The Great Grid Upgrade

Sea Link

Volume 9: Examination Submissions

9.76.5 Change Request: Addendum to Volume 6 Environmental Statement

Document Title: CHANGE 3 - CHANGE TO THE ORDER LIMITS AT FRISTON TO PROVIDE FLEXIBILITY IN RELATION TO HERITAGE FEATURE, SUFFOLK

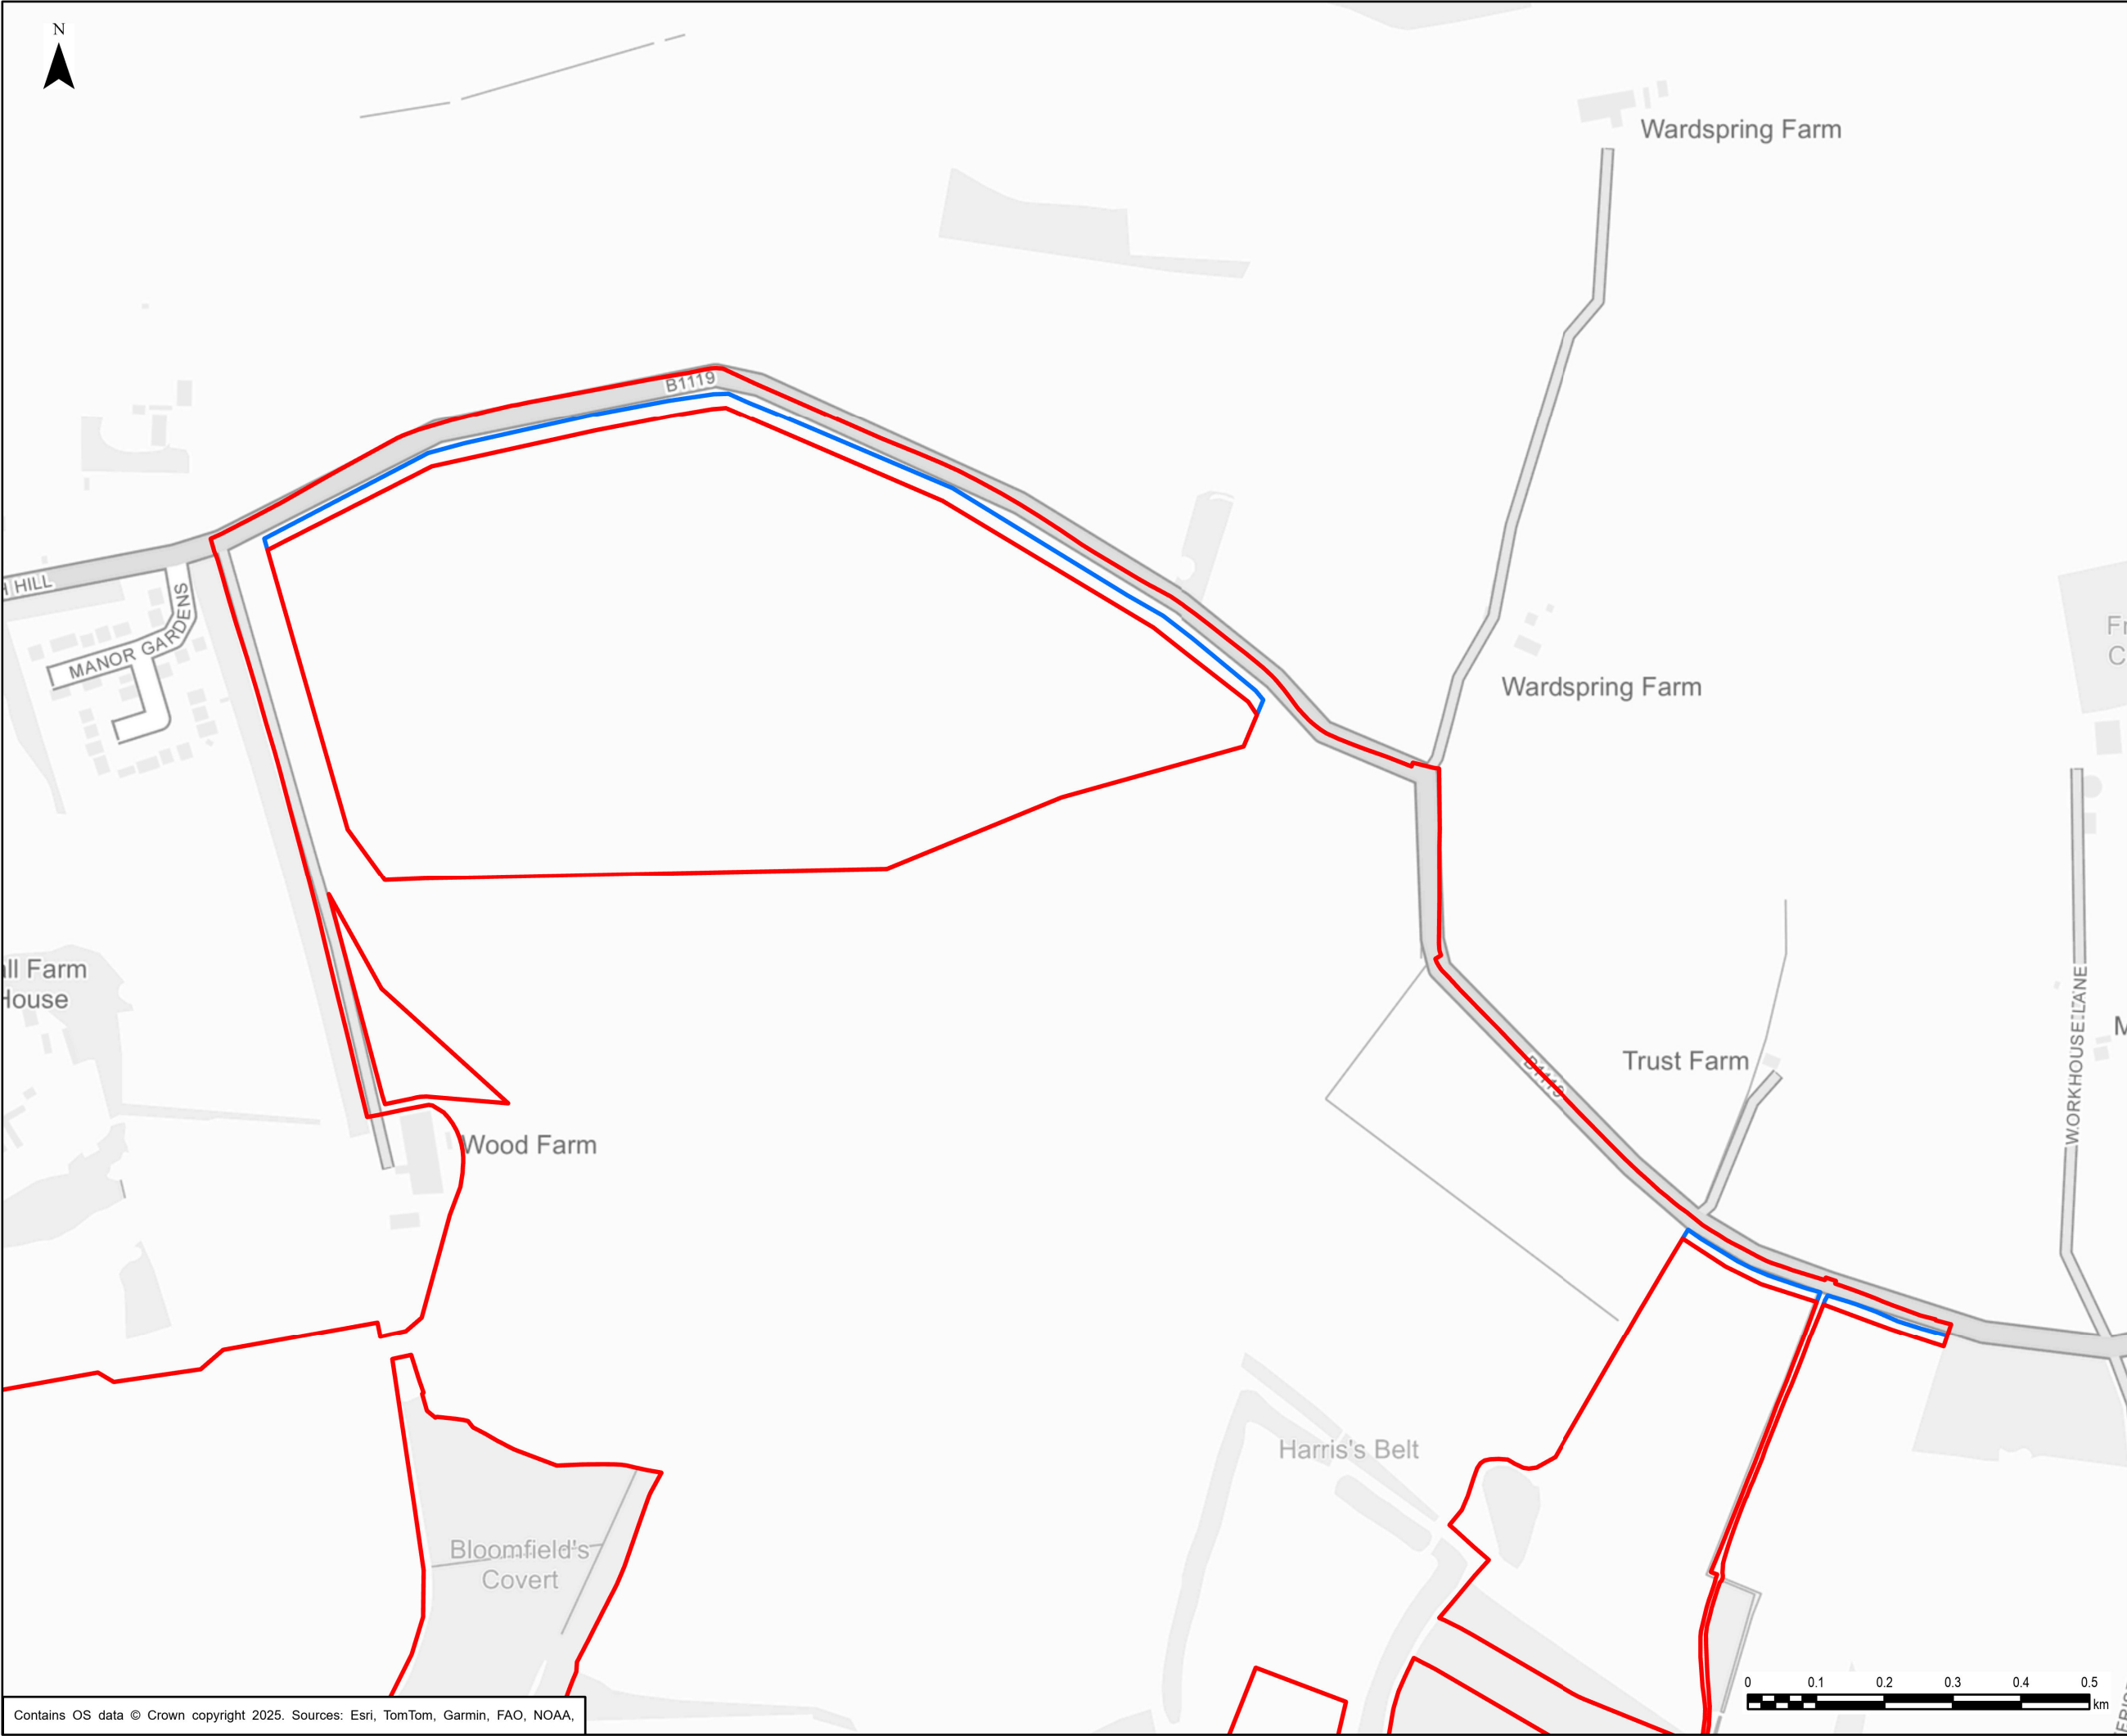
- 2.4.2 It was initially proposed in **Application Document 9.19 Sea Link DCO notification of change to DCO application [AS-138]** to amend the Order Limits to remove the potential Neolithic hengiform feature from the Order Limits and to introduce additional land to enable the underground High Voltage Direct Current (HVDC) cable to be routed around the feature. However, further geophysical survey of the area around the potential hengiform feature completed in October 2025 indicates that the asset is a D-shaped enclosure rather than a henge. The results of the further geophysical survey are included in **Application Document 9.76.5.2 Appendix B: Geophysical Survey Report** submitted at Deadline 1A.

- 2.4.3 The geophysical survey also identified potential archaeological features of interest in the area to the west of the heritage feature and no potential archaeological features in the area to the east of the heritage feature, where the Order Limits were proposed to be extended as set out in **Application Document 9.19 Sea Link DCO notification of change to DCO application [AS-138]**.

- 2.4.5 For the Change Request, National Grid proposes to retain the option of being able to install the cable route and haul road as set out in the submitted DCO application with an expansion to the Order Limits around the heritage feature in order to allow full excavation of the heritage feature (if required). The Order Limits are also extended to the east to provide the flexibility to respond to the results of the additional evaluation trenching which is due to be completed, should avoidance of the heritage feature be the preferred option following the analysis of the results. The area to the west of the heritage feature, which was included in **Application Document 9.19 Sea Link DCO notification of change to DCO application [AS-138]** is no longer included in the Change Request. This is due to the potential archaeological features that had been identified in this area during the additional geophysical survey. This approach is supported by HE and the SCCAA.

- 2.4.6 The proposed change is shown in Figure 3.

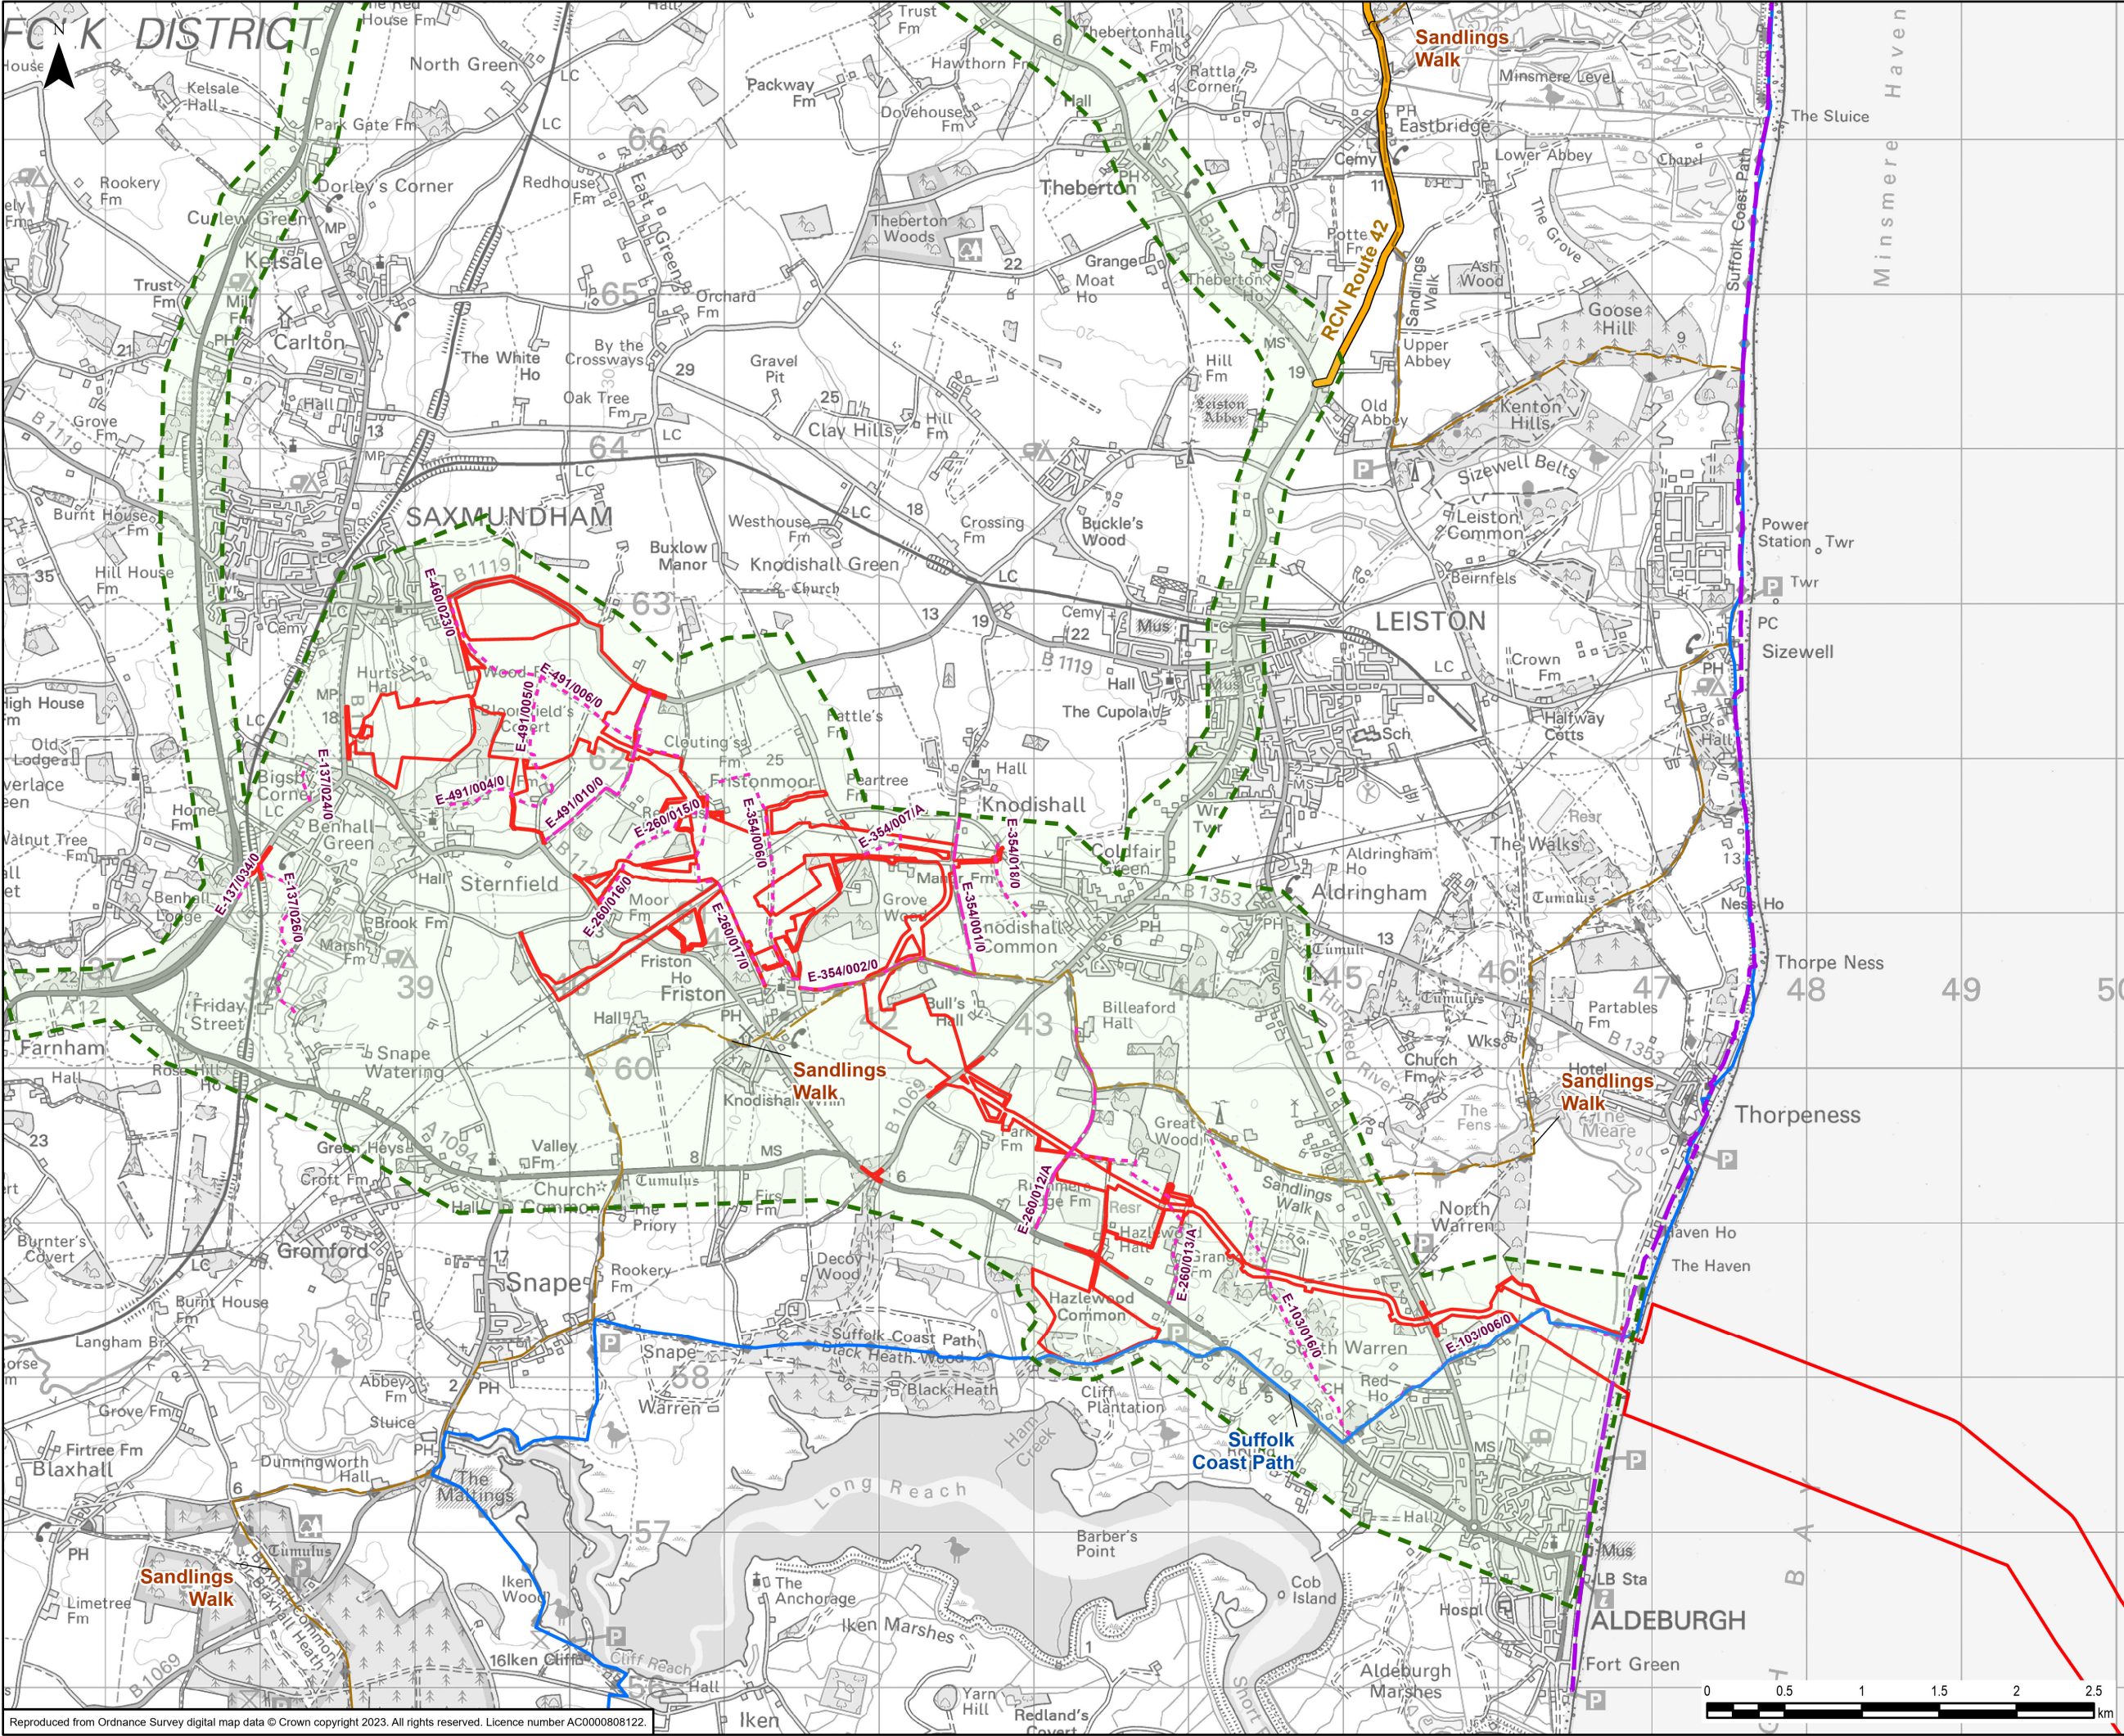
- Ex1.5.5 In addition, both options would require the northern end of PRow E-137/026/0 to be temporarily closed when road closure(s) are in place. **Application Document 6.4.2.7.4 Walking and Cycling Routes (including PRows and Bridleways) – Suffolk Onshore Scheme (Version 2, change request)** has been updated for Deadline 1A to include this PRow and is included in the Figures at the end of this Addendum. Additional mitigation, including keeping the remainder of the PRow open, installing signage to advise users of the closure/works and making a shuttle/taxi service available to residents of Whitearch Park Residential Park Homes (who do not have access to a vehicle), which is secured as part of measure TT11 within both the Outline Construction Traffic Management and Travel Plan and the REAC, means that there is no potential for significant adverse effects to arise.
